BAR Meeting
September 7, 2011

ISSUE: Permit to Demolish and Rear Addition

LOCATION: 929 South Columbus Street

Figure 6: Existing and proposed floor plans; proposed elevations.

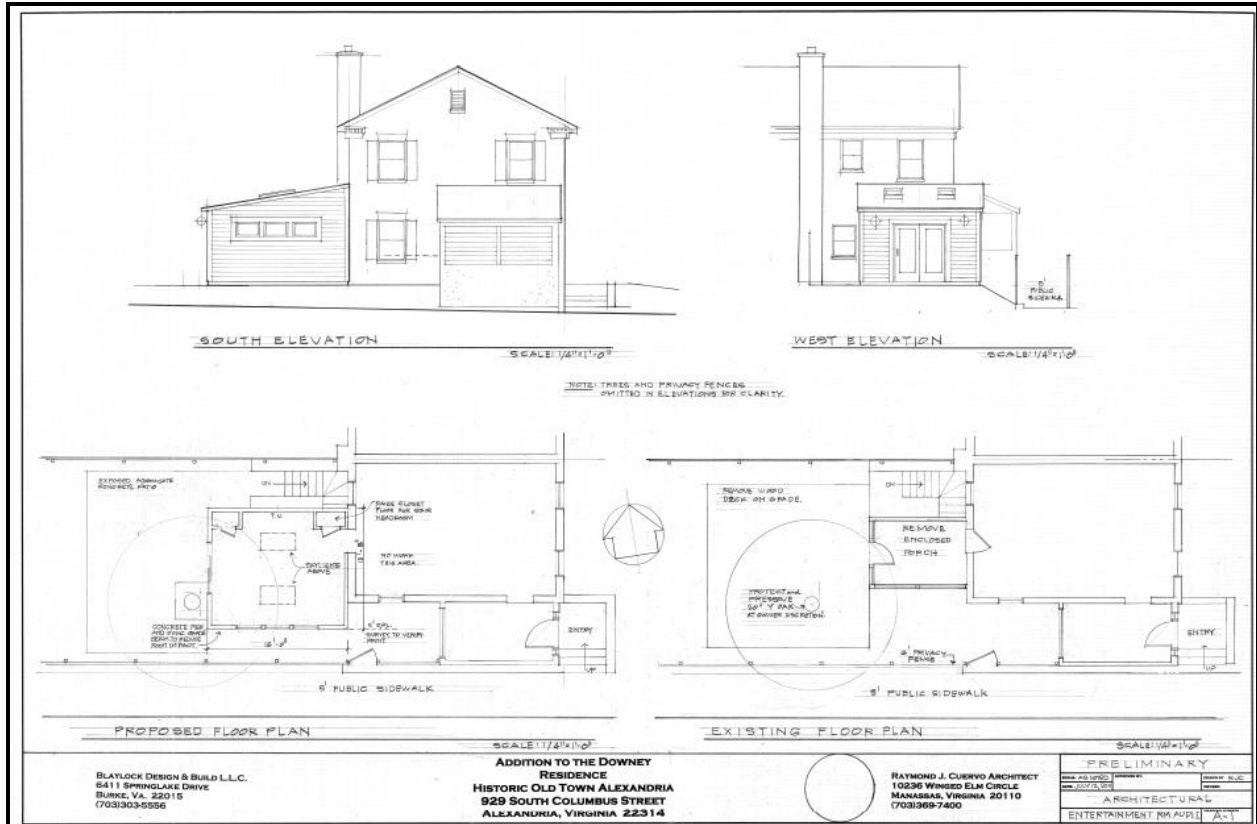
The applicants propose to construct a new, larger one-story rear addition that will measure 16 feet deep by 14 feet wide (224 square feet). The addition will be slightly offset from the rear elevation in order to retain access to an existing basement entrance. The addition will project beyond the south plane of the end unit townhouse by three feet. The addition will have a shed roof with two flush skylights and three tab composition shingles to match the existing roof material.

The south elevation of the rear addition will have three awning style clerestory windows, while the rear (west) elevation will have sliding French doors flanked by two lights. The aluminum clad wood windows and doors will be manufactured by Pella, and, although the drawings show interior sandwich muntins, they will be installed without muntins. The north elevation will be devoid of any openings. The addition will be clad with white Hardieplank siding.

In the opinion of Staff, the design of the addition is generally compatible in style and massing with the historic townhouse and conforms to the *Design Guidelines* for additions. The *Guidelines* encourage “designs that are respectful of the existing structure and which seek to be background statements or which echo the design elements of the existing structure.” As the attached drawings illustrate, the proposed addition will not overwhelm the existing building and will clearly read as a separate and distinct addition due to the change in the roof structure (shed roof instead of gable roof), materials (frame with Hardiplank siding rather than brick) and fenestration (clerestory awning windows and sliding French doors instead of double-hung windows). While Staff does not believe the design of this utilitarian addition would be appropriate on a 19th century building or if it were on any side more visible from a public street, it is in the rear and the shed roof form is very similar to the existing south addition and to other rear additions on this same block.
